**ADDENDUM NO. 2**

Date of Addendum: February 7, 2023

Project Name: Gaston County Schools – Grier Middle School

- A. Owner: Gaston County Schools
- B. Architect: LS3P
- C. Architect Project Number: 9201-218240

**ENLARGED GRADING PLAN**  
**C6.1**

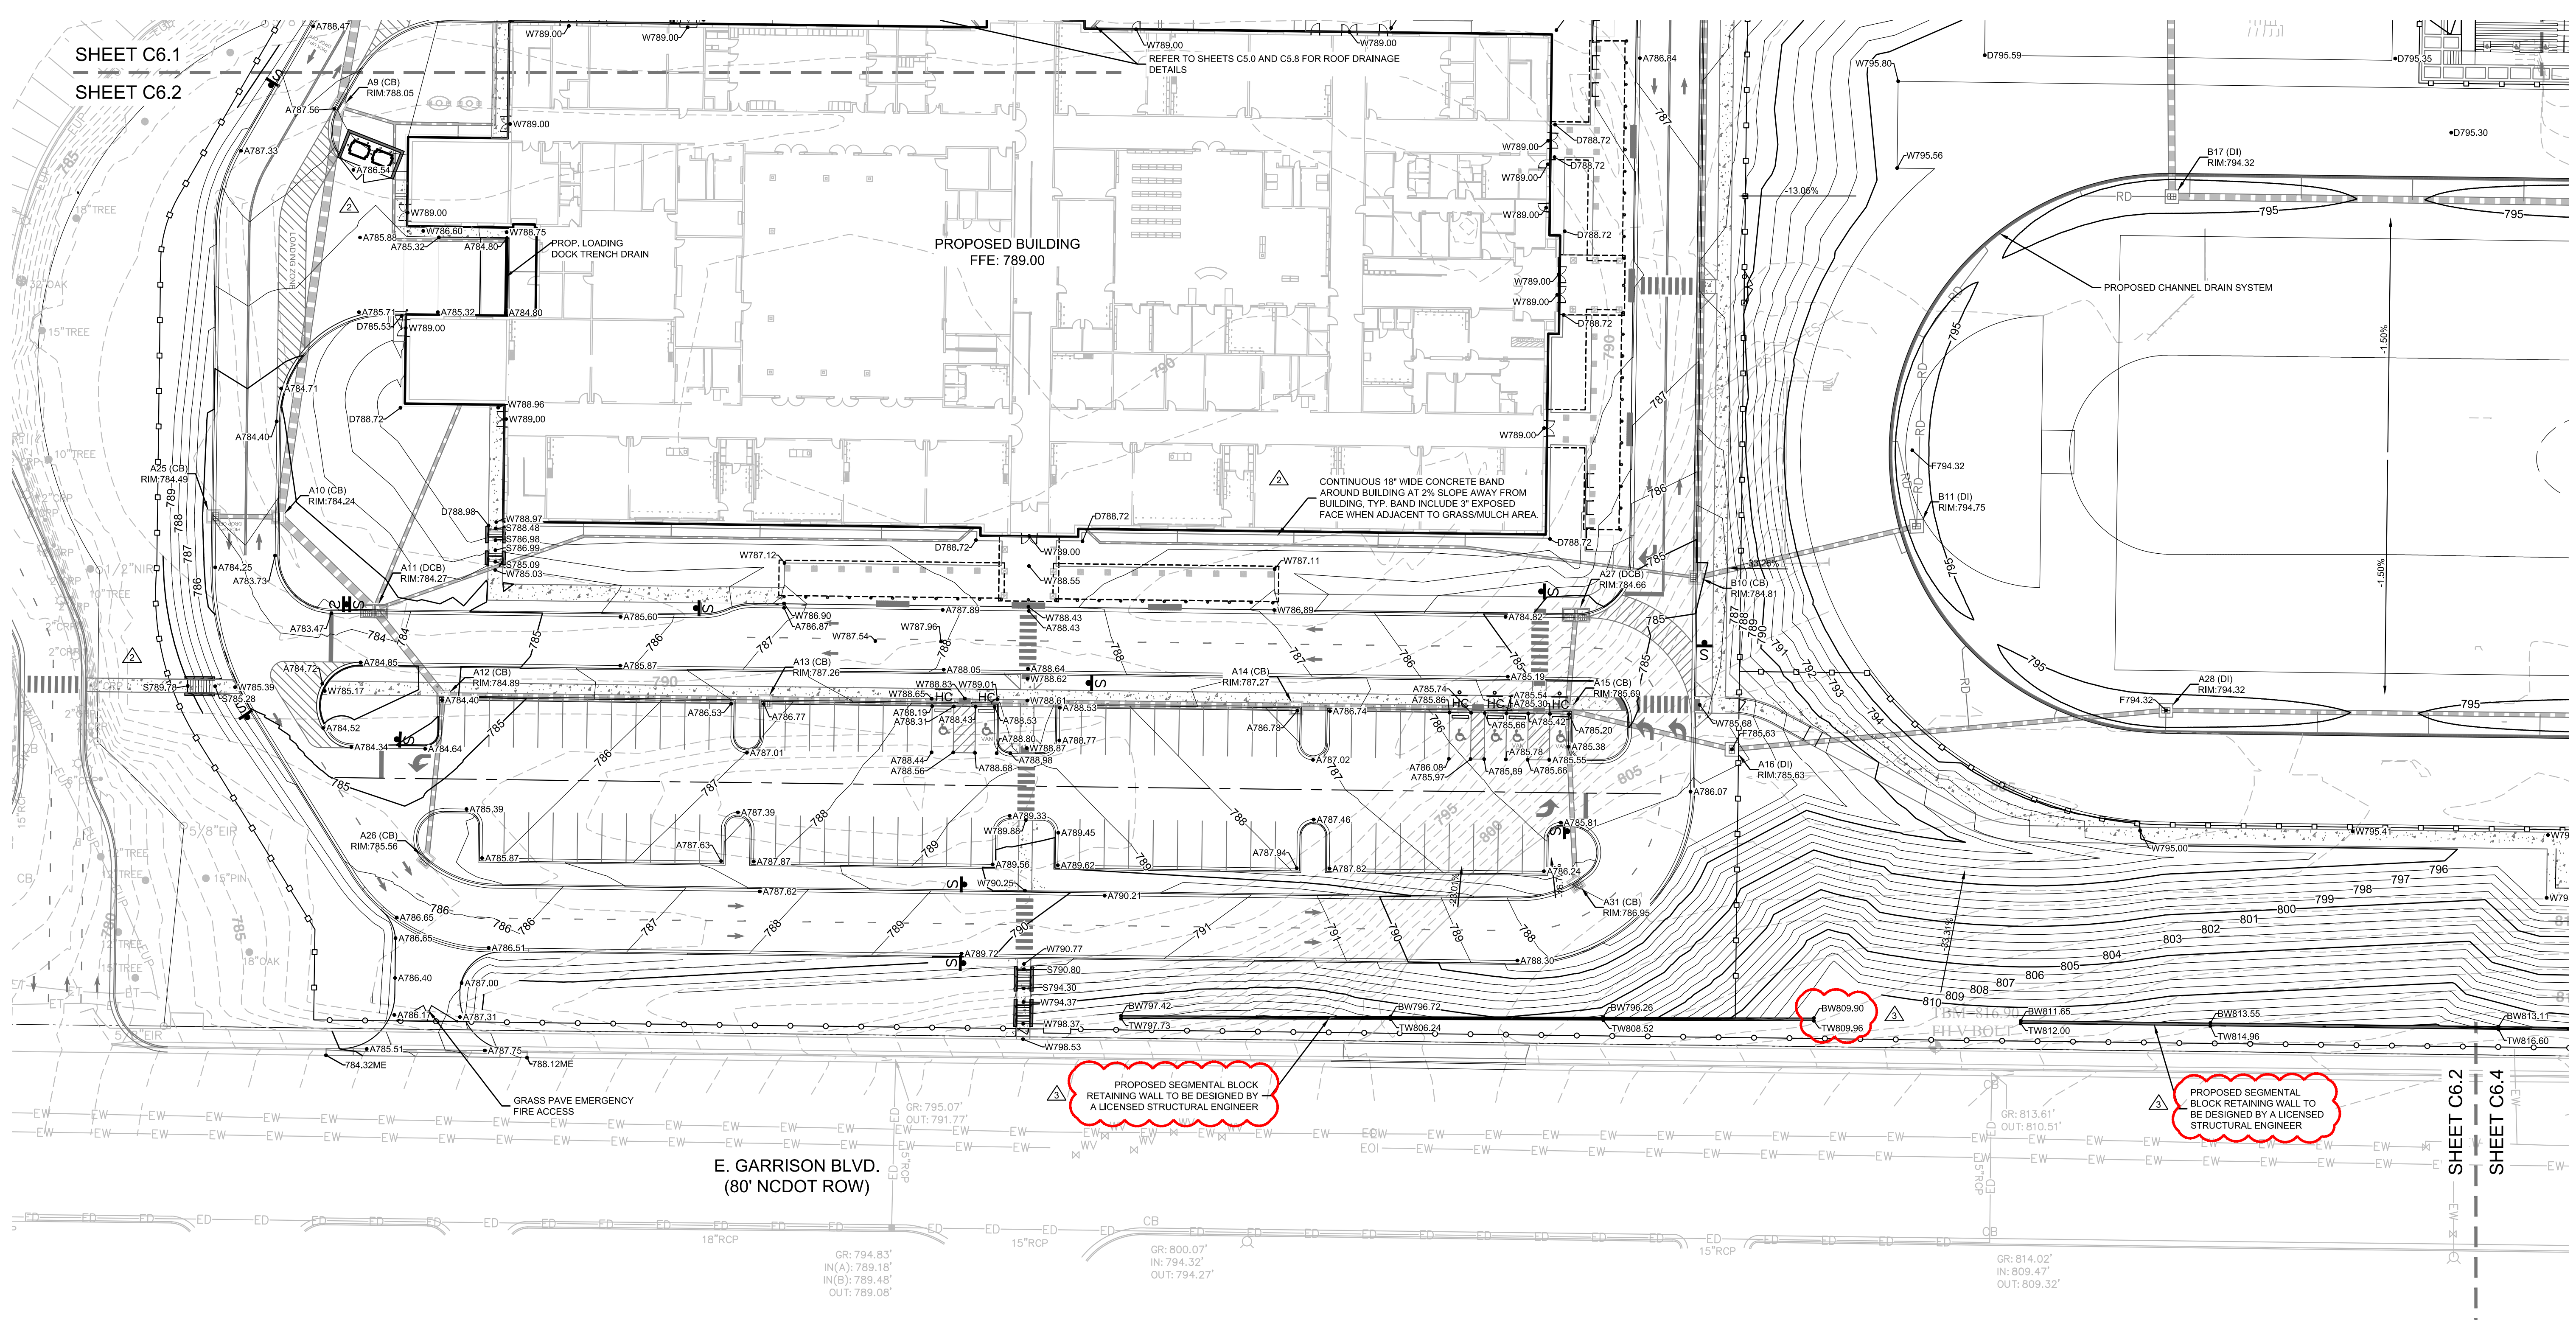
1. Specify types of retaining walls.
- H. Replace SHEET C6.1 – ENLARGED GRADING PLAN with revised Sheet C6.1, included in the attachments.
1. Specify types of retaining walls.

- 
2. Add top of wall and bottom of wall spot elevations to 2 sets of stairs at gymnasium.
  - I. Replace SHEET C6.2 – ENLARGED GRADING PLAN with revised Sheet C6.2, included in the attachments.

**ENLARGED GRADING PLAN**  
**C6.2**

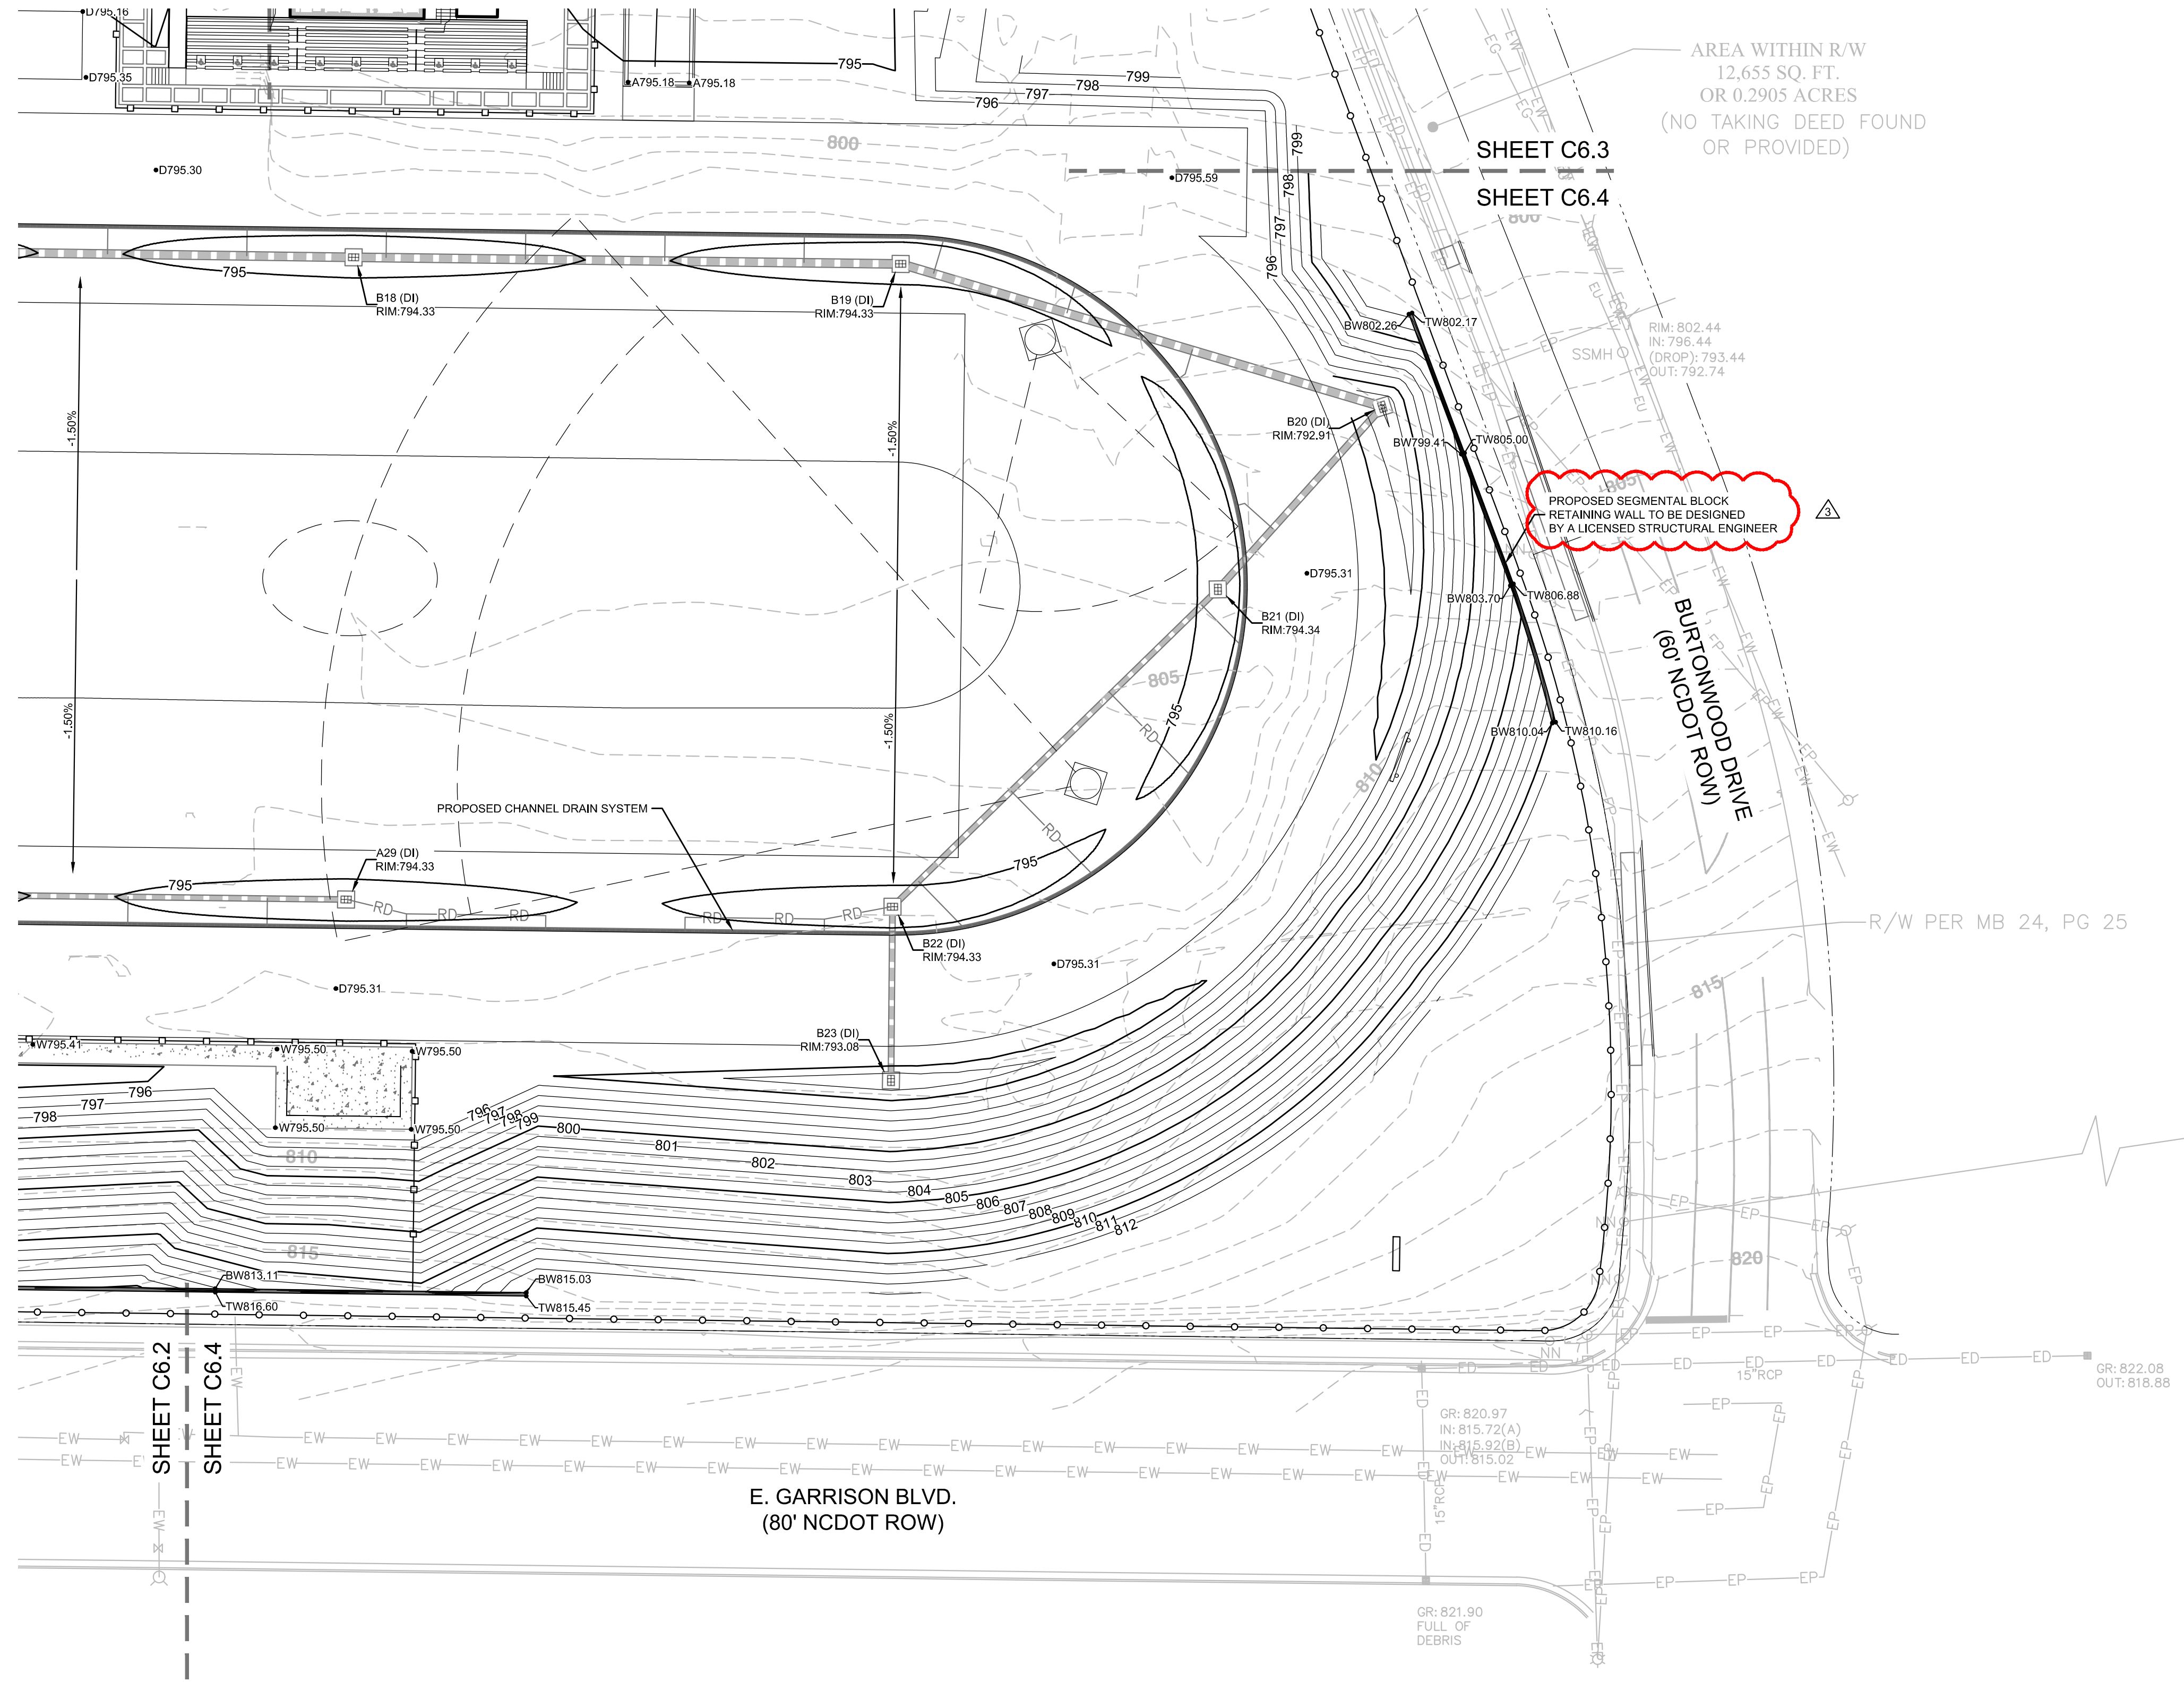
1. Specify types of retaining walls.
    2. Revise bottom of wall spot elevation.
  - J. Replace SHEET C6.4 – ENLARGED GRADING PLAN with revised Sheet C6.4, included in the attachments.
